Amendment A00003

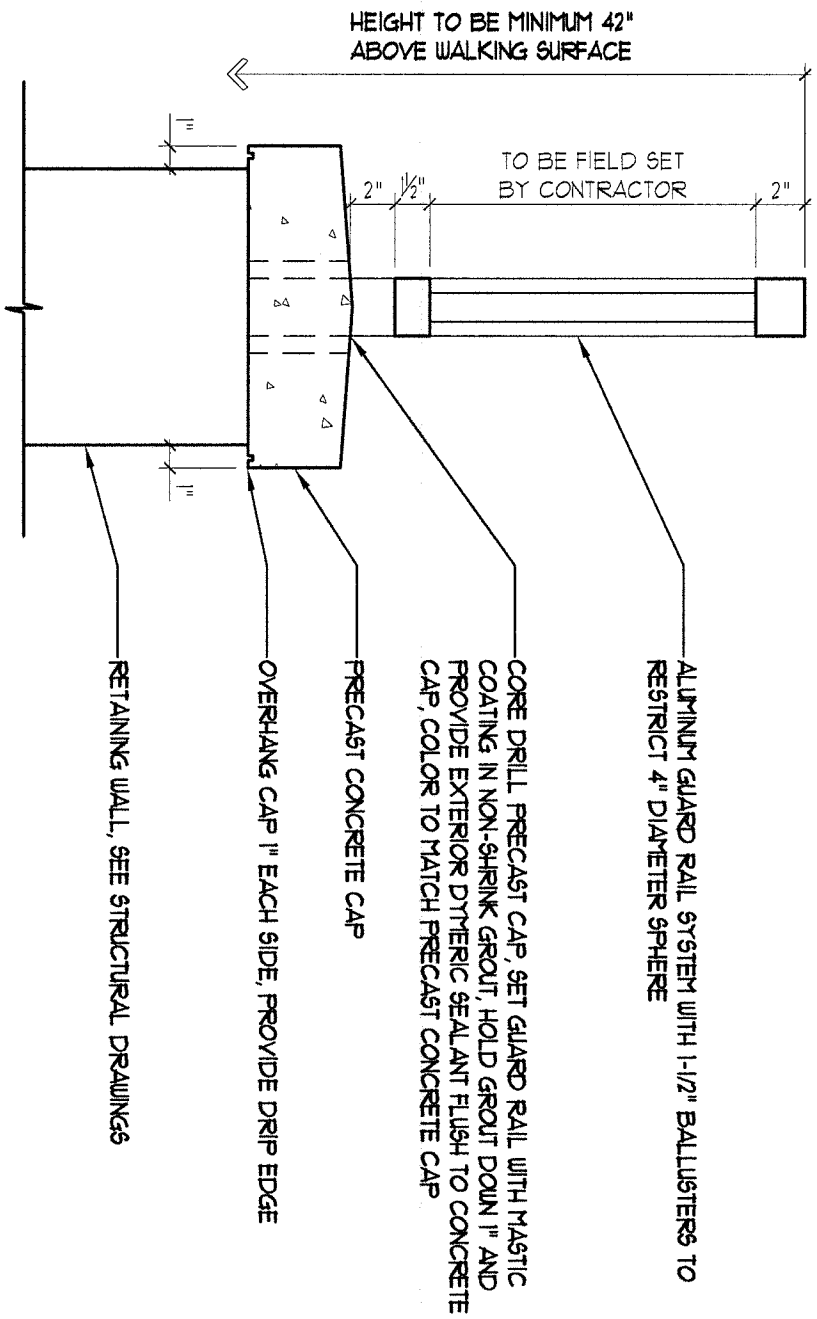
3. Drawing CS109A is for the alternate 4 with the connector deducted from the project. A pedestrian bridge is to be provided to the new 2nd floor. The note states "by Structural Engineer". No provision on the structural drawings is shown to provide information to price this bridge. Please provide information on this bridge.

Response: See attached section and notes on CS109A
